Onderwerp Mijlpaal Waterveiligheid RvdR Ontpoldering Noordwaard

Onderwerp
Toetsing hydraulische berekeningen voor de Eindontwerp maatregel "Ontpoldering Noordwaard"

**Review of Noordwaard
Eindontwerp hydraulic
computations**

Figure 2.3 Location of the dikes (kades) changed by the project. Source: Royal HaskoningDHV (2016)

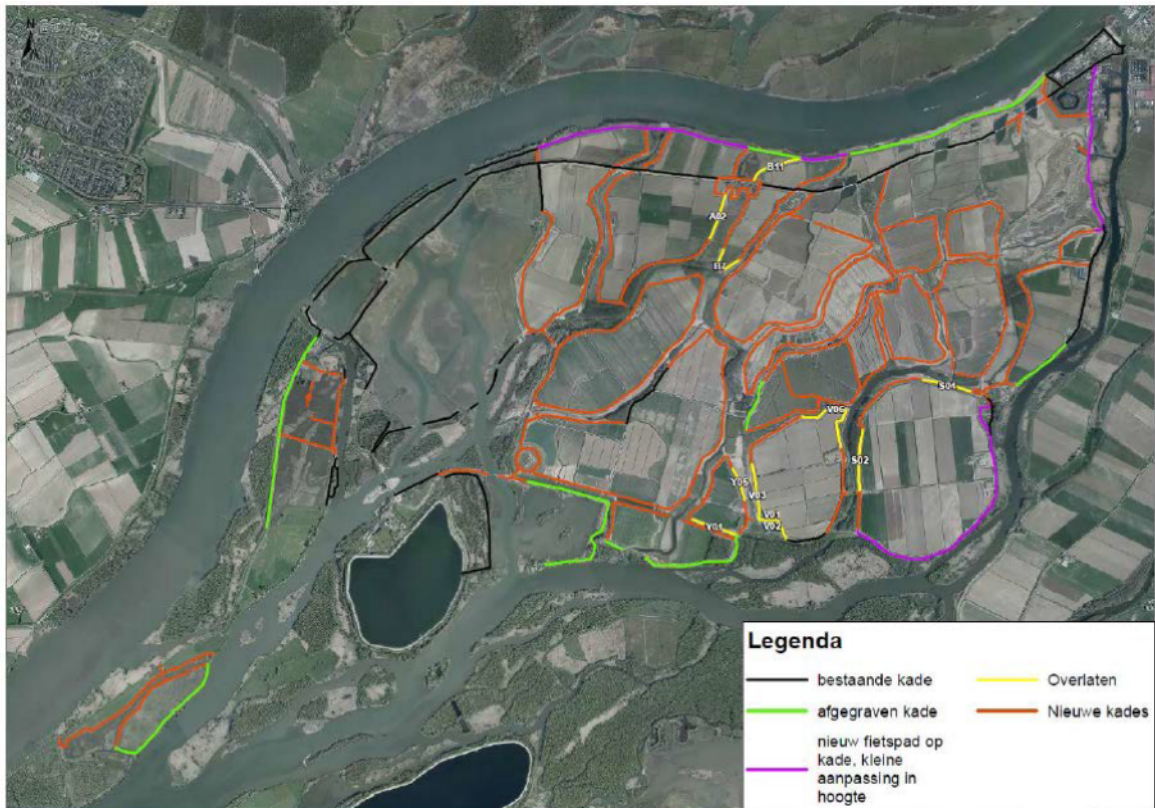
- While for the new kades the maximum allowed settlement of 10 cm is applied in the schematisation, it is not clear why the expected settlement has not been computed.

The new dikes are schematised via kade feature in Baseline, which means that they are anticipated as weir structures and not incorporated in the bed elevation. The following conclusions can be drawn regarding the schematisation of the dikes (Baseline kade feature):

Figure 2.4 Data source of the creeks and other elevation features (RHDHV, 2016)

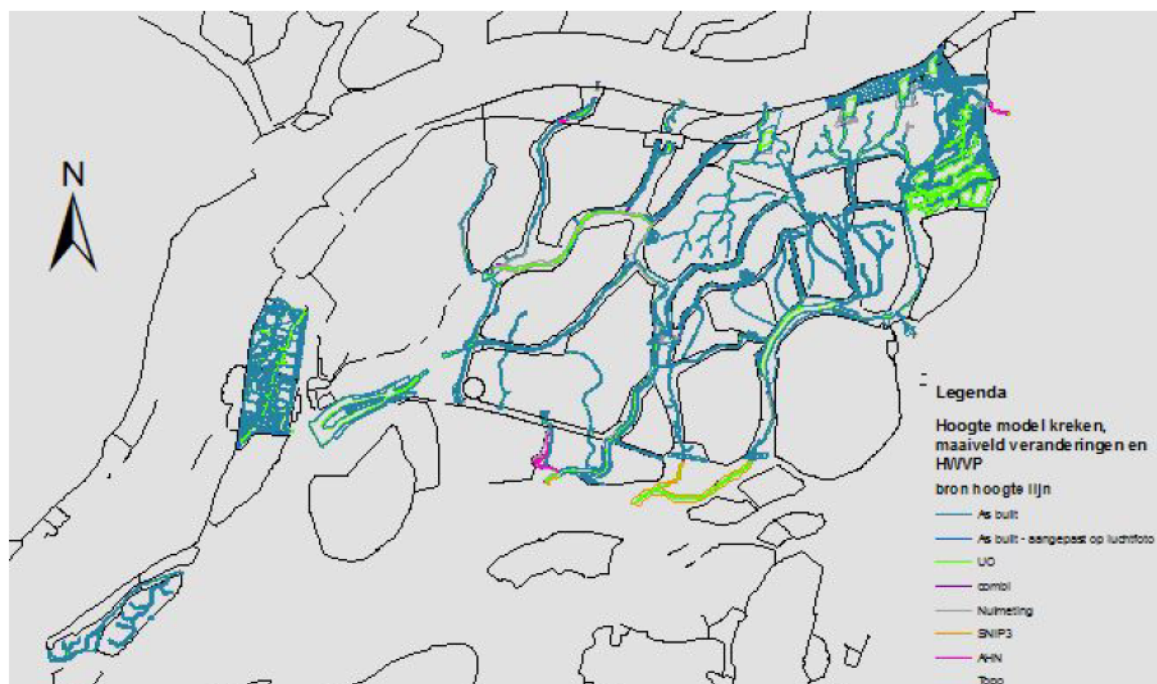
As summarised in Section 2.3.3, the hydraulic advisor does not make full use of the As Built measurements for schematising the creeks. Instead the bed elevation of the creeks is schematised based on what Hydraulic Advisor describes as “Intervention level of the uitvoeringsontwerp”. This was described as 30 to 50 cm higher bed elevation than the “uitvoeringsontwerp”. During the review it was observed that:

- the schematisation incorporates a bed elevation of the creeks which is up to more than 1 m shallower to the As Built measurements.
- the elevation line surrounding the creeks which has obtained the elevation information out of the reference situation schematisation (used in SNIP3 phase) differs significantly from the measurements.
- the connection between new and existing creeks is not fluent as shown in Figure 2.17. This could be fixed by updating the schematisation of the area which is not subject to change by the RvdR project. In some locations obstacles are present in the creeks as well. These obstacles (erroneous model schematisation) need to be removed.

Figure 2.9 Comparison between the schematized kade heights and the measurements for the new kades given as "As Built measured elevation – kade crest elevation"

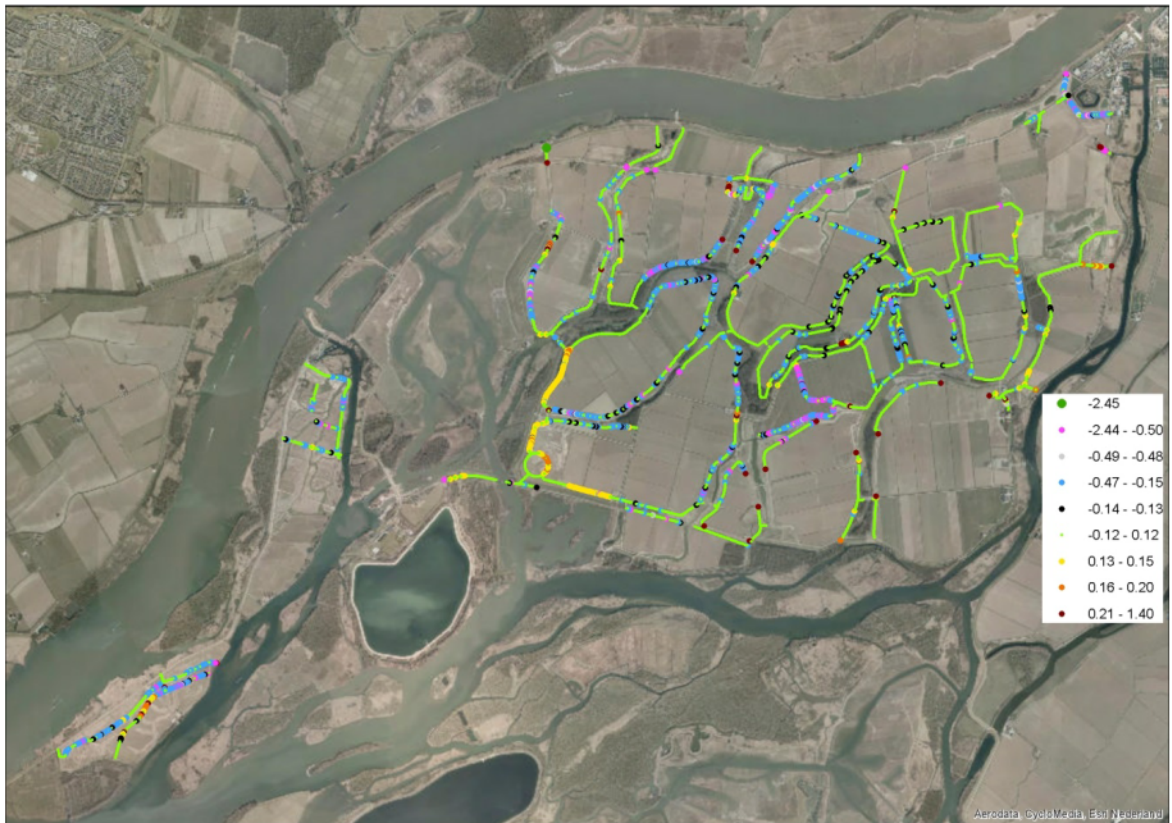
- The kade line is not always having the measured crest elevation irrelevant of the applied settlement. According to RHDHV (2016), the elevation points along the kade lines are defined as interpolation between the measured kade crest lines. There are three measurements lines present on the kades changed by the project. Often the middle line has a higher elevation then the surrounding side lines, sometimes one of the side lines has a higher elevation then the two other lines. Considering these measurements data, the hydraulic advisor has decided to make an interpolation between the elevation lines. During the review we observe the following. The crest elevation of the modified kades (lowered or increased) is not always corresponding to the measurements.

In order to gain an overview of the kade crest elevation, the schematized value is contrasted with the measurements. If the crest elevation deviation between the interpolated elevation value corrected with the anticipated settlement and the schematisation is between a ± 2 cm margin, then it is shown in green colour in Figure 2.7. If the difference is more than 2 cm, it is shown with red colour (schematized too low compared to the measurement) or blue color (schematized too high compared to the measurement). Note that this figure does not contain the overflow kade sections (“overlaten”). Several red dots are seen on the sides of the kade lines, that is due to the connection to the old reference situation schematisation. In Figure 2.8 it can be seen that the differences are above 5 cm and amounting up to more than 10 cm for the existing modified kades. The differences between the measured and schematized crest elevation for the new kades is above 12 cm. Anticipating the settlement of 10 cm, one concludes that the differences in elevation are generally more than 5 cm (see Figure 2.9). These deviations are partially caused by the fact that the kade position is not according to the measurements, sometimes the field measurements consist of strong deviations on the measured elevations within a short distance, and could be slightly influenced by the comparison method used in this analysis which is not necessary the same to the schematisation method used by the hydraulic adviser.

To conclude: Deltares does not fully agree with the method used for schematising the kades (position of the kades) and discrepancies are observed between the field measurement and the crest elevation considered in the schematisation. These deviations are partially caused by the fact that the kade position is not according to the measurements, sometimes the field measurements consist of strong deviations on the measured elevations within a short distance, and could be slightly influenced by the comparison method used in this analysis which is not necessary the same to the schematisation method used by the hydraulic adviser. The hydraulic effect of these deviations cannot be assessed.

Figure 2.12 Kade in the South-West side of Polder de Kroon

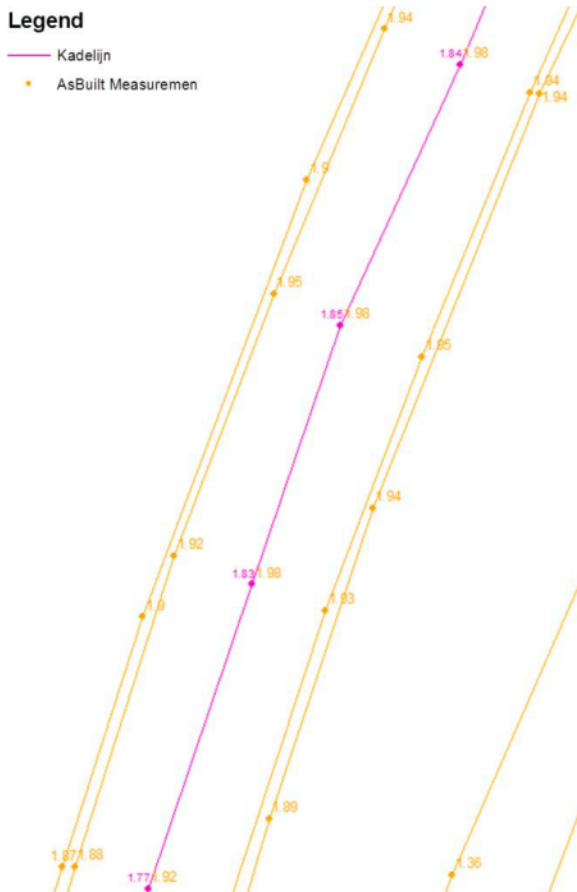
In the Polder de Kroon (at location 2 in Figure 2.7) part of the kade line corresponds to the measurement line (Figure 2.12). However, kade elevation points in schematisation are 13 cm and 14 cm lower than measured (see Figure 2.12).

Figure 2.13 Kade in the Western side of Polder de Zalm

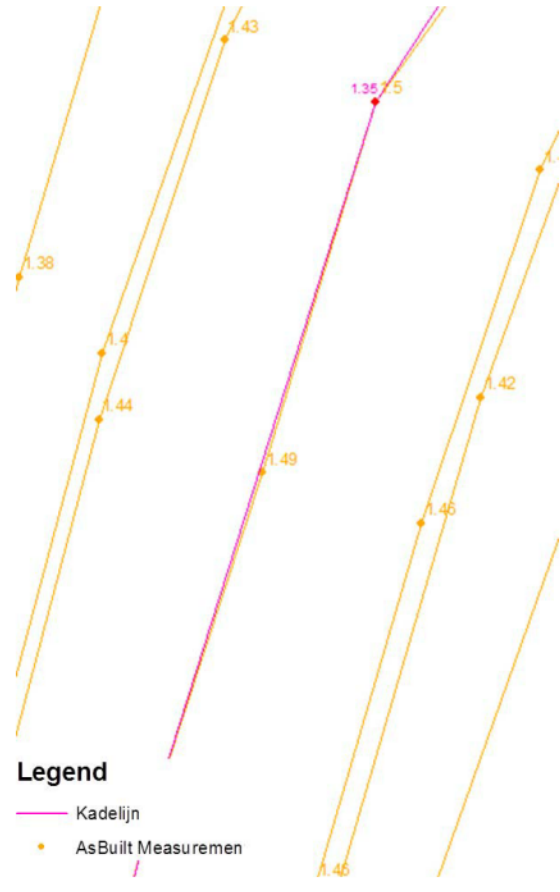
Similarly in the Polder de Zalm (at location 3 in in Figure 2.7) part of the kade line corresponds to the measurement line (Figure 2.13). Again, the elevation of the new kade line is not extracted from the underlying measurement line, but seems to have been considered as the average of the two crest side line elevations anticipating the 10 cm maximum settlement.

Figure 2.14 Kade in the South-Western side of Polder de Zalm

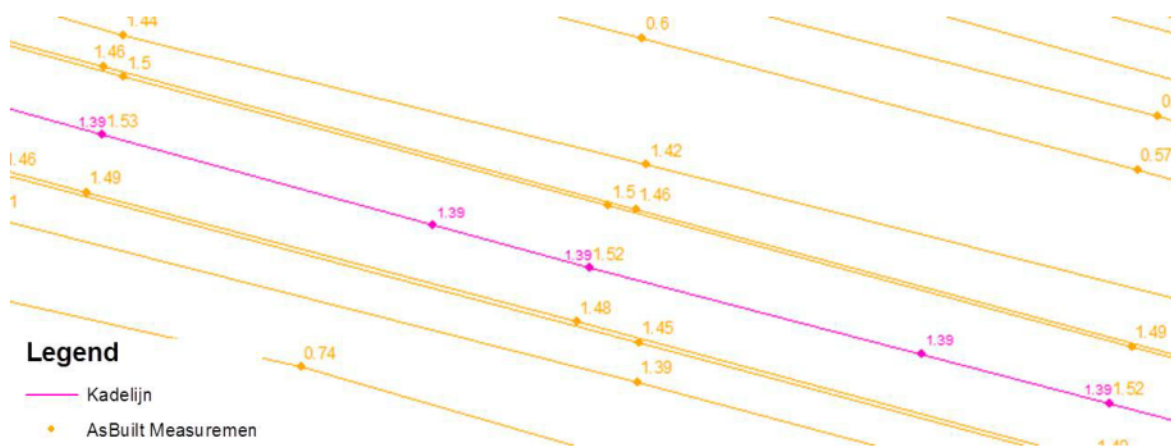
Also in the South-Western side of Polder de Zalm (at location 4 in Figure 2.7) the measured and schematized points coincide, but their elevation is different. Taking into account the settlement, the difference is still 3 cm (Figure 2.14).

Figure 2.15 Eastern side of the Polder Maltha

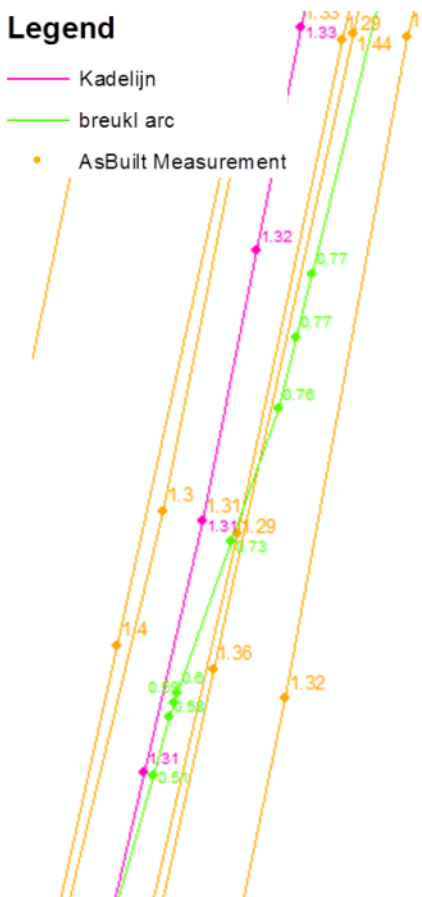
In the Eastern side of Polder Maltha (at location 5 in Figure 2.7) the “breuklijn” crosses the kade lines with different elevation (Figure 2.15). The “breuklijn” crossing the kade lines needs to be removed. Instead two breuklijnen need to be defined on both sides of the kades.

Figure 2.17 TIN of the Recreatiepoort

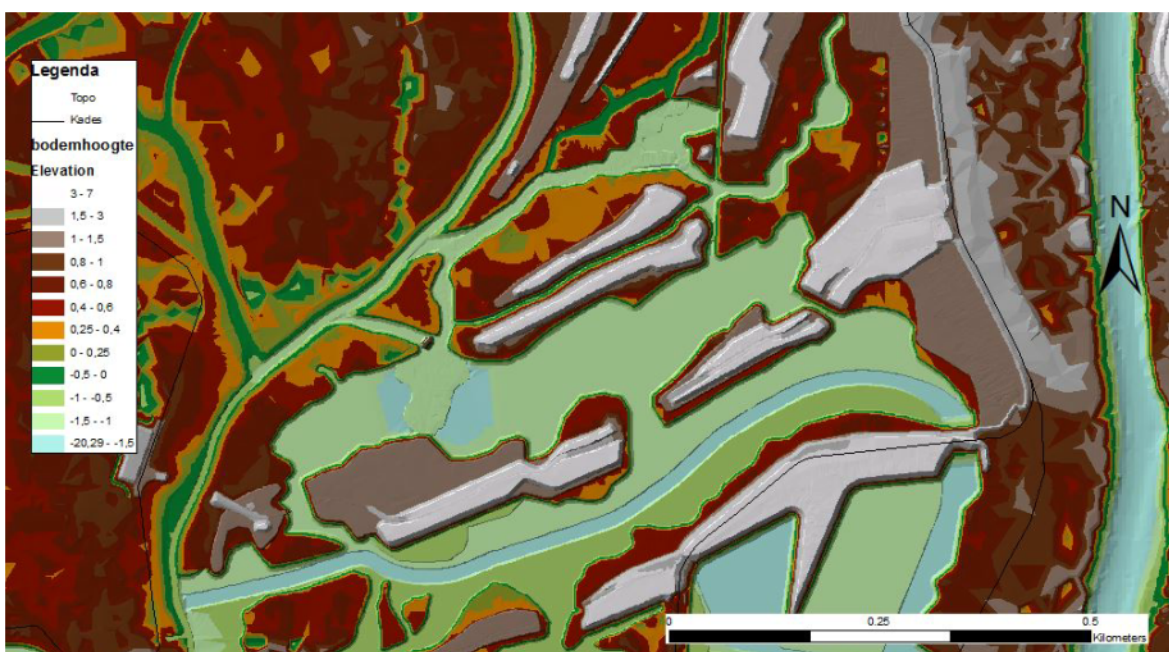
To conclude: The creeks are not a good representation of the As Built measurements. It is not possible to quantitatively assess the influence of this discrepancy on the computed hydraulic effects.

It is strongly recommended to not use the current model or schematisation for any other project. Deltares recommends changing the creek schematization based on the As Built data for future schematisations.

Figure 2.18 Terp 52

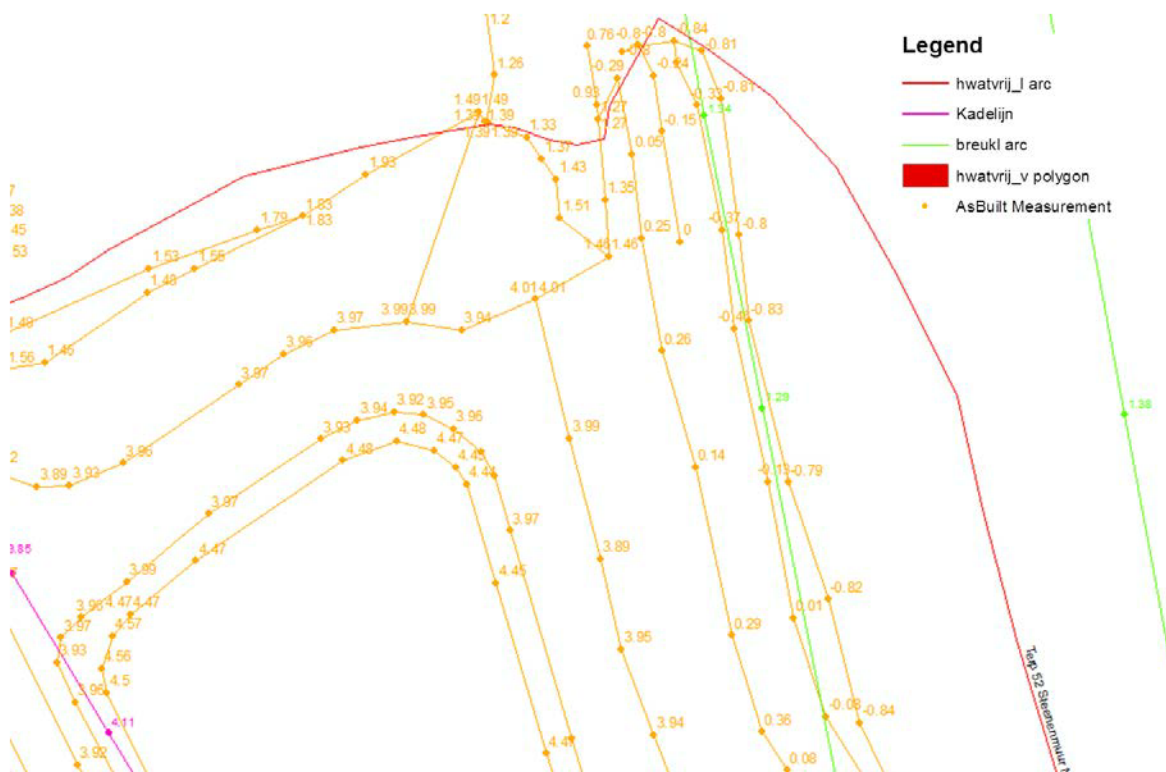
At Terp 52 (Figure 2.18) the area encircled by the hoogwatervrij line is bigger than the measured area of the *terp*. In fact, inside the circle there are several lower elevation points. The schematization of the mound could be improved.

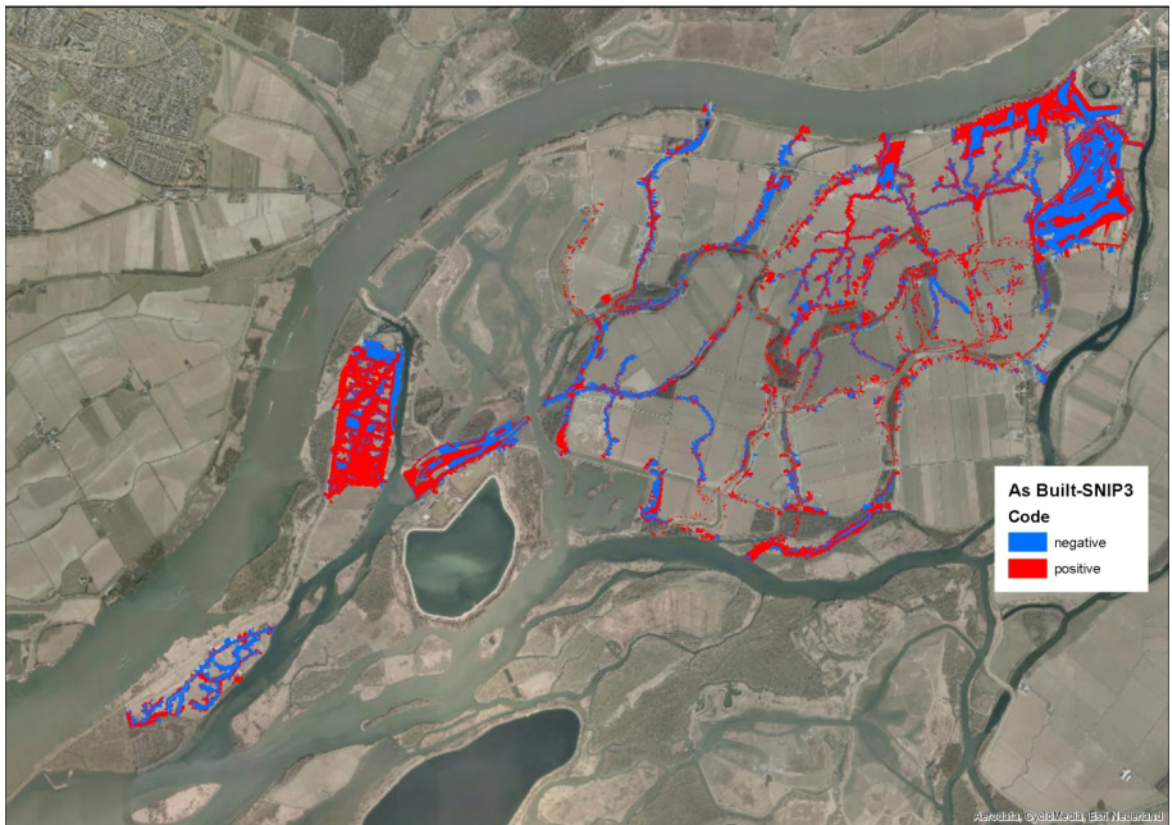
- The differences in the bed elevation (Figure 2.19) between the SNIP3 and Eindontwerp schematisation are limited to the project features (Figure 2.2).
- Directly besides the creeks higher areas can be found in the TIN of the Eindontwerp variant schematisation. Upon closer inspection of the aerial photograph (Figure 2.21) and vegetation map (Figure 2.22) the higher grounds (Figure 2.20) correspond with the *oobos* along the river. The schematized high terrain is most likely a result of taking the treetop height instead of the bed elevation. The hydraulic effect, if any, would likely increase if these areas are adjusted. It is recommended to adjust the schematisation based on recent measurements.

Figure 2.23 Interventiekaart of Noordwaard.

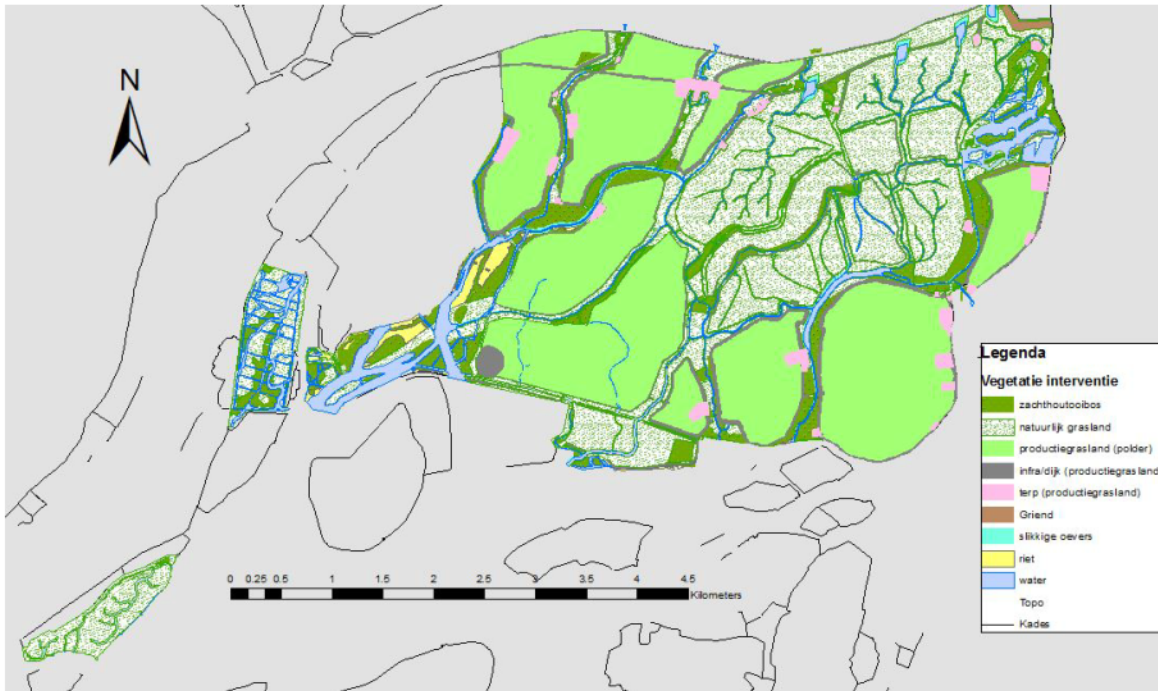
The interventiekaart (Figure 2.23) is nearly the same as during the SNIP3 phase with few changes. The main vegetation at Hillpolders is changed from Zachthoutooibos (code=1804) to Natuurlijk Grasland (code=1202). The South-western part of Noordwaard is schematised as productiegrasland. The review conclusions are as follows:

- There is a small area where the roughness code 0 is present. The polygon needs to be given the correct roughness code.
- The changes to the *ruwheidv* Baseline coverage extend beyond the measure area (Figure 2.24). The changes are present only in the Eindontwerp variant and not present in the reference schematisation.
- The Eindontwerp vegetation schematisation (Figure 2.24) does correspond to the delivered interventiekaart (Figure 2.23).
- Detailed elements like trees and bridge pillars are not included in the schematisation. These roughness elements should be taken into account in other schematisations in the future.
- It is recommended to include the creeks in the “plassen” Baseline coverage in future schematisations.

To conclude: There are some inconsistencies in the created schematisation. The hydraulic effect of these inconsistencies is not known.
